Determination 2025/055

The compliance of a return section of a retaining wall with clause F4 Safety from falling

1206B Hikuai Settlement Road, Pauanui, Coromandel

Figure 1: The retaining wall and barrier, looking toward the west

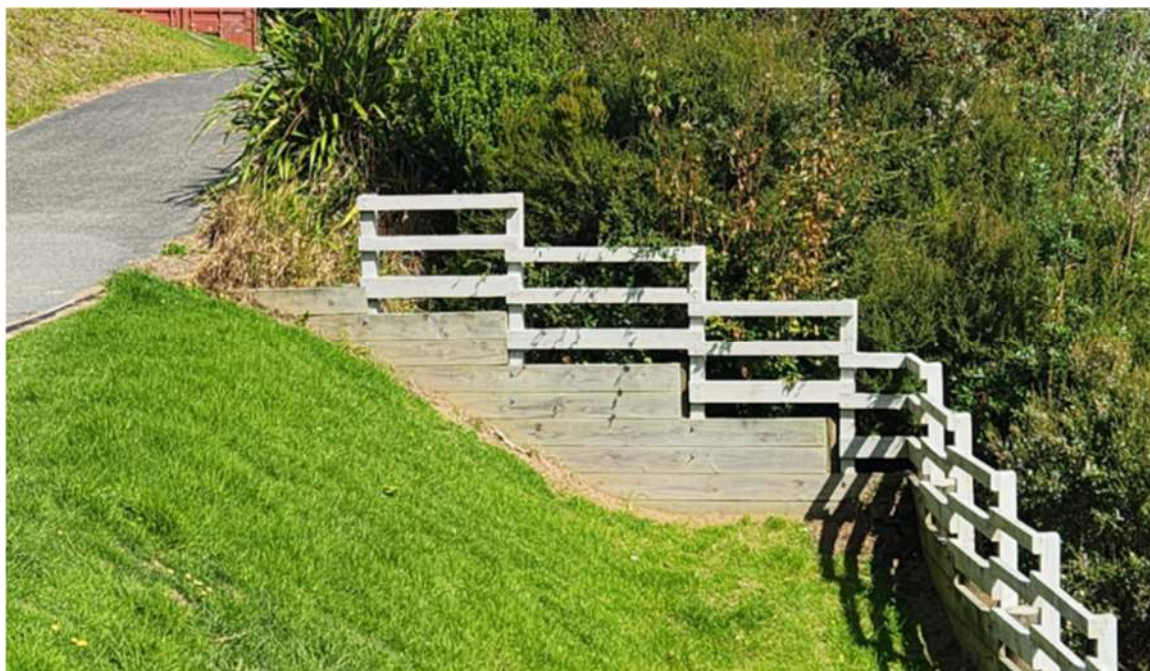
- 2.1. The return section of the retaining wall (“the retaining wall”) has been constructed in a north-south direction. It is perpendicular to and connects at the western corner of the main retaining wall (“the west-east retaining wall”) that was the subject of the previous determination (see Figure 1). The retaining wall has been constructed

- 3.18. The barrier construction on the return section of the retaining wall has the same construction as that on the west-east retaining wall, with vertical gaps between horizontal members of the barrier that would not restrict the passage of children under six years of age.

- 3.19. I consider the dimensions of the retaining wall and the horizontal members of the barrier provide a readily climbable structure that would enable a child under the age of six to easily climb the barrier and either pass through or over it. In particular for the retaining wall at its southern end the lagging boards are level with the ground forming the driveway; this provides easy access to the top of the lagging where children can negotiate their way along the retaining wall to where the fall increases on the west side to more than 1 metre.

- 3.20. I therefore consider the barrier does not comply with the requirement to restrict the passage of children under six years of age.

- 5.1. In accordance with section 188, I determine the timber barrier on the return section of the retaining wall does not comply with Building Code clause F4.3.4(g).

Figure 2: Diagram of the retaining wall and barrier heights (not to scale)

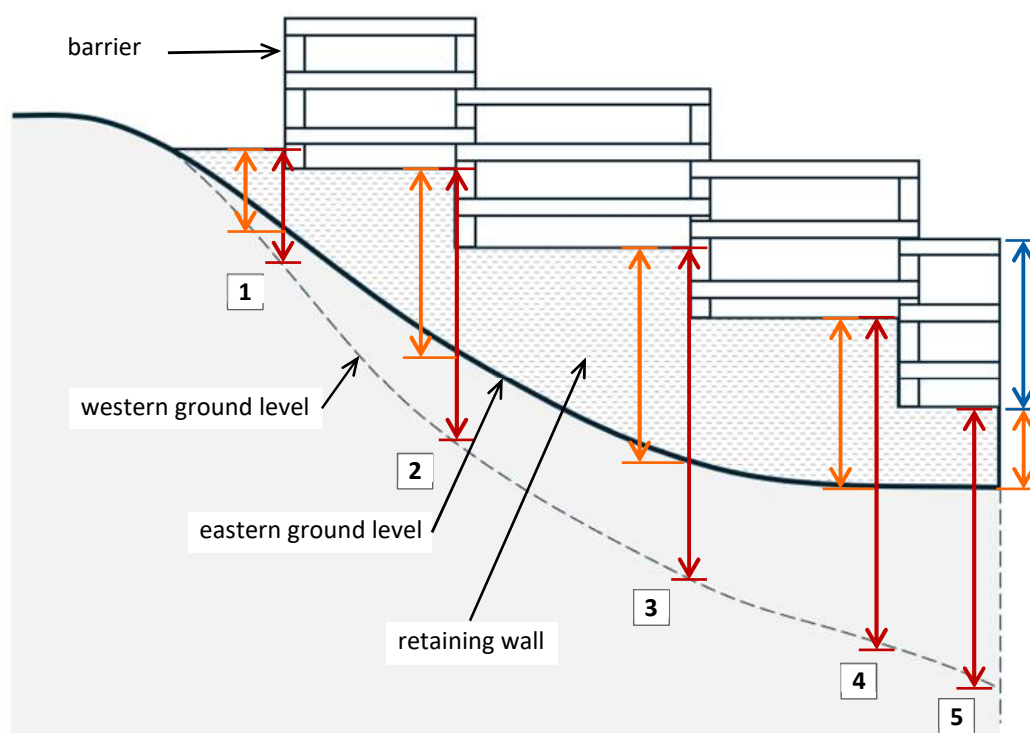
2.2. The retaining wall is stepped to follow the land contour and so the height of the retaining wall varies from 0.6 to 1.7 metres (measured to the top of the lagging boards to the adjacent ground). The retaining wall begins level with the ground at the southern end.

2.3. The differences in ground levels along the length of the retaining wall are less than 1 metre, except in the northern corner where it is approximately 1420mm. On the western (lower) side of the wall, the site slopes away to the north, continuing past the west-east retaining wall.

- 3.13. Along the return section, the retaining wall itself is in some places up to 1140mm above the adjacent ground level to the east. However, in other places it is much lower and therefore does not on its own provide safety from falling.

- 3.14. The barrier height on the retaining wall is approximately 900mm above the lagging boards. At its lowest point, the lagging boards on the retaining wall sit 100mm above the finished ground level on the east (top) side. The overall barrier height that restricts falling will be 1000mm or more along the length of the retaining wall. Therefore, I consider the overall height of the barrier complies with clause F4.3.4(b).

- 4.1. A barrier is required by F4.3.1 because there is a sudden change of level associated with the retaining wall that people could fall 1 metre or more from.
- 4.2. The barrier complies with F4.3.4(b) because it is an appropriate height.
- 4.3. The barrier does not comply with F4.3.4(g) because it does not restrict the passage of children under six years of age.
